414 California Avenue is currently a bank and financial services business in the CC, CC(2)(R)(P) Palo Alto Zoning District. The proposed scope of work is to continue the Bank and Financial services use under a new operator, Silicon Valley Bank. The use and function of the building will be consistent with the previous tenant and the scope of work will not change the footprint of the building, the floor area, or the overall massing.

SUBJECT – PROJECT ARBORIST'S RESPONSE TO THE CITY OF PALO ALTO'S PLAN REVIEW COMMENTS CONCERNING THE PROPOSED IMPROVEMENTS AT 414 CALIFORNIA AVENUE:

Please find the information you requested pertaining to the Notice of Incomplete/Corrections Required/Interim Report, dated 09/20/2022 (Application No. 22PLN-00207).

Attachment – Image of the Extent of the Tree Canopy Cover over the Parking Area

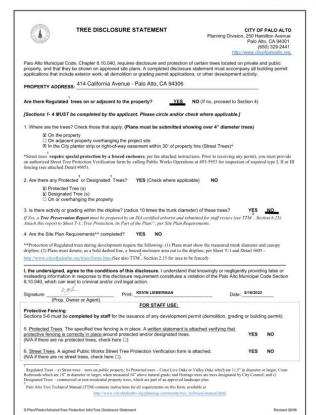
2- The city requested a calculation be provided concerning the extent of the shade provided by the canopies of the existing trees over the parking area (Tree's #3 through #6 in the arborist report). I determined that the canopies of the four large trees within the proximity of the parking area provide shade to approximately 60% of the parking area surface (see the attached image for more information).
